Project Title: Land South of Green Road, Wivelsfield

Report Reference: TRP-00048

ESCC HIGHWAYS RESPONSE NOTE 01

Figure 3 – Green Road existing footway widths along the site frontage

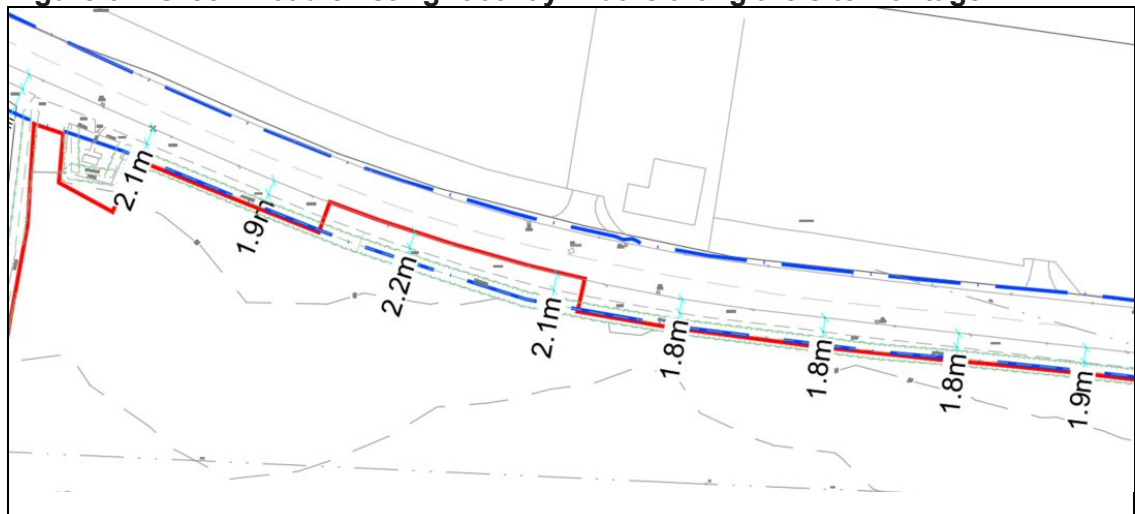
Para 3.12 states “ ... existing footways on the local roads that will connect to the development site are considered appropriate...”. This is not accepted. The footways surrounding the site need to be widened where possible to 2m to the new bus stops; Primary School and shop to east at least including the footway along the whole of the site frontage.

- 1.47 The development will provide a new 2m footway on Eastern Road to connect the site to Green Road. The provision of the new footway was agreed with ESCC as part of the pre-application discussions and is a significant improvement for the scale of the development.
- 1.48 The existing southern Green Road footways ranges between 2.2m to 1.8m width measured from the topographical survey and shown in **Figure 3**.

- 1.49 The width of the existing footway provision is considered suitable to comfortably accommodate two-way pedestrian movements. The existing footway width exceeds 2m in places and is very close to 2m in others. The cost benefit of providing circa 100-200mm extra width along the entire frontage is questioned.
- 1.50 The southern footway to the east of the site on Green Road provides connections to the shop and school. The southern Green Road footway to the east of the site is shown in **Figure 4**.

Figure 6 - Tree Constraints Plan

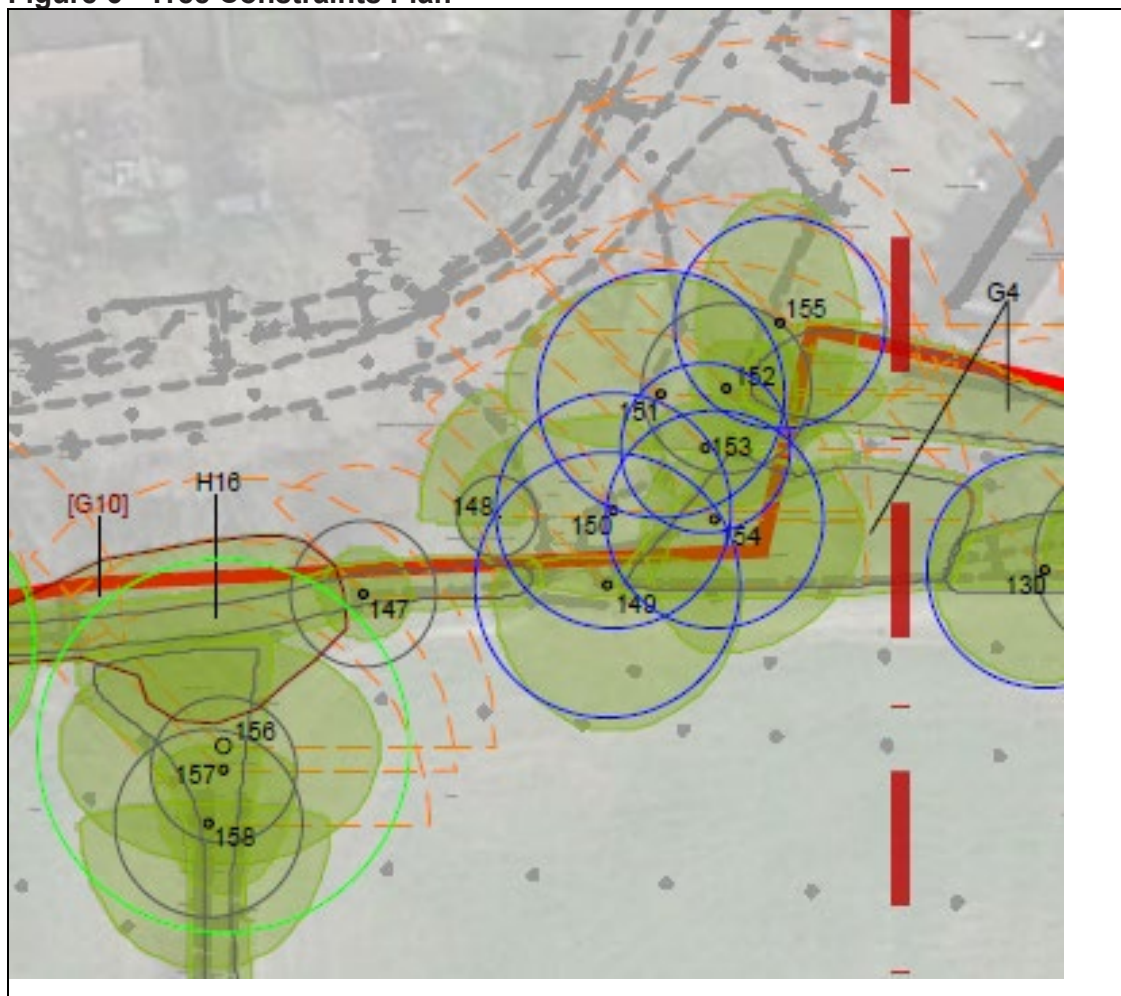
Recommend position of proposed combined cycle/footway onto Eastern Road is revised slightly further northwards?

- 1.61 The combined footway / cycleway onto Eastern Road has been located to minimise its impact on the existing trees and to focus the impact on low quality scrub. It is not possible to move the connection further north without detrimental impact on the trees. The position of the connection has been based on the advice of the arboriculture consultant. **Figure 6** details the trees to the north of the proposed footway / cycleway.

Appendix 2 - Updated Site Access and Refuse Vehicle Swept Path

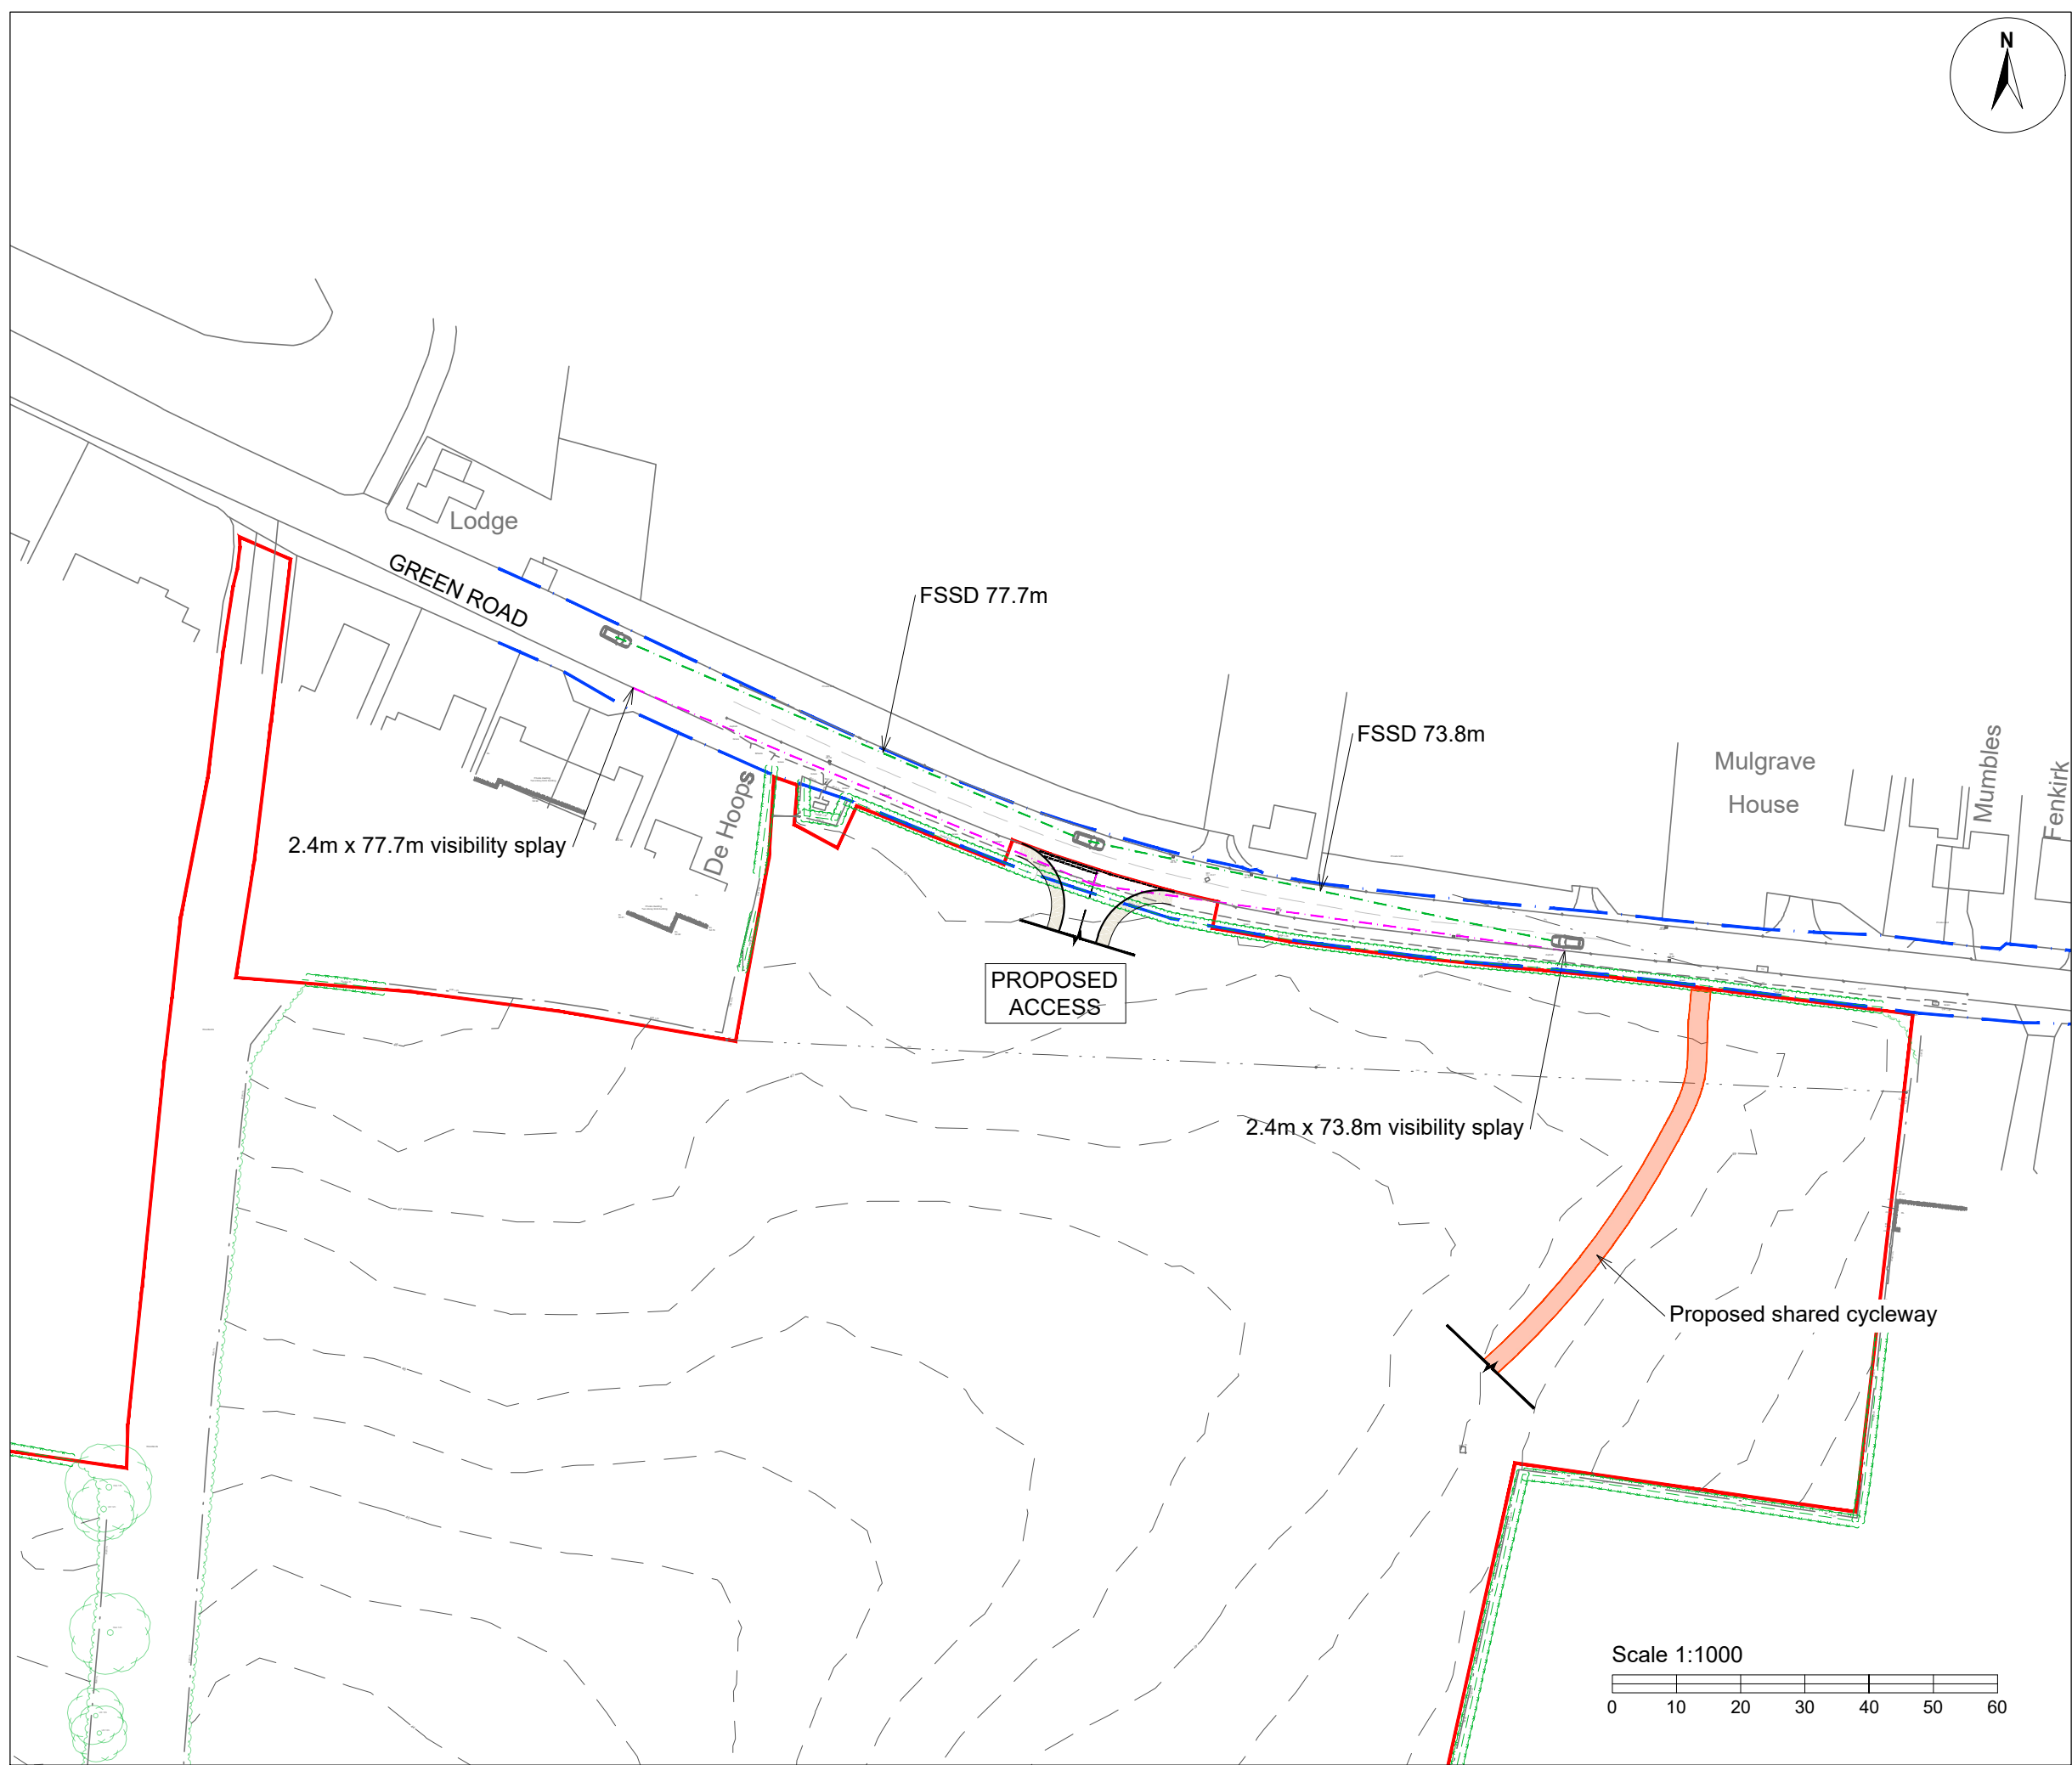
The RSA raises 3 problems of which most have been/can be satisfactorily answered within the Designers Response and/or by condition/s106 requirements. However, Problem 4.2.1 of the Audit refers to the geometry of the proposed access onto Green Road not being satisfactory; the Designers Response is not accepted by the Highway Authority. The tracked drawings indicate that a refuse vehicle of 11.6m in length would have to use the whole of the carriageway of Green Road in order to make a left turn out of the access. Equally a left into the site uses the whole of the access point. Given the current traffic flows and conditions along the C6 (Green Road) this is not acceptable and the junction radii should be increased accordingly.

- 1.35 However, to address your concern it is proposed to increase the width of the access from 5.5m to 6m and the junction radii from 6m to 10m. This will ease the junction for the larger vehicles as requested.
- 1.36 A suggested junction design and swept path analysis for a large refuse vehicle is provided at **Appendix 1** (794-PLN-TRP-00048-DR-0004 rev B and 794-PLN-TRP-00048-DR-004 Rev A). If you would prefer to see this junction design as part of the application, please confirm in writing and we can submit the plan to the LPA on a formal basis.

B	Access radii increased to 10m	AJ	MSB	19/03/25
A	Red line boundary and FSSD added	AJ	MSB	23/10/24
Rev	Description	By	CB	Date
